SEC Modification Proposal, SECMP0244, DCC CR5312

Device Alerts for Smart Meter Credit Replenishment

Preliminary Impact Assessment (PIA)

Version:	0.3
Date:	27th February 2024
Author:	DCC
Classification:	DCC CONTROLLED

Figure 1: Process Flow for Supply Enabled New Alert

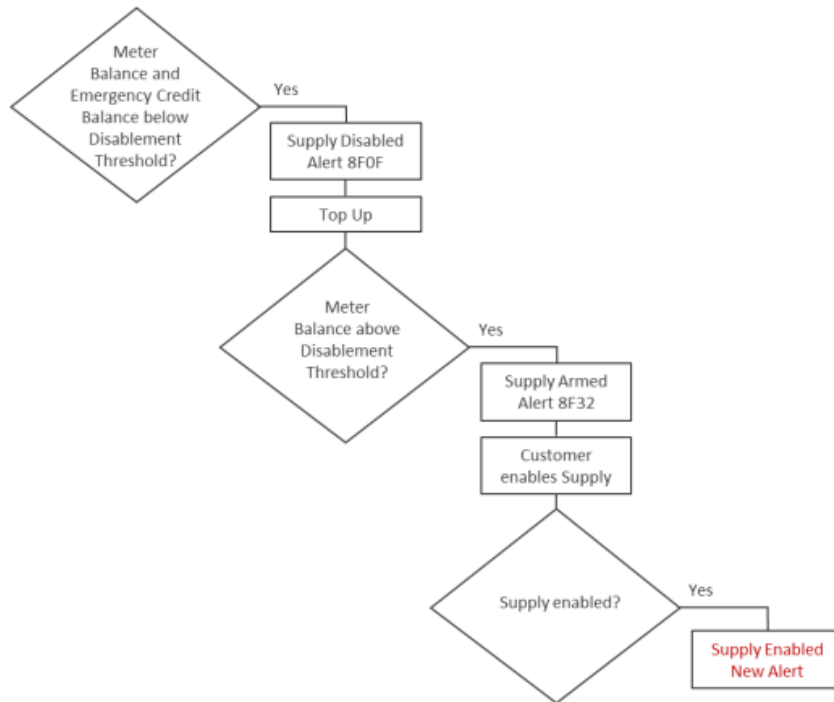
DCC notes that the Supply Armed Alert could be seen as an adequate indicator that the customer has taken some action to top up the meter balance; is the new Enabled Alert seen as an indicator of prepayment customers who Self-Disconnect or Self-Ration?
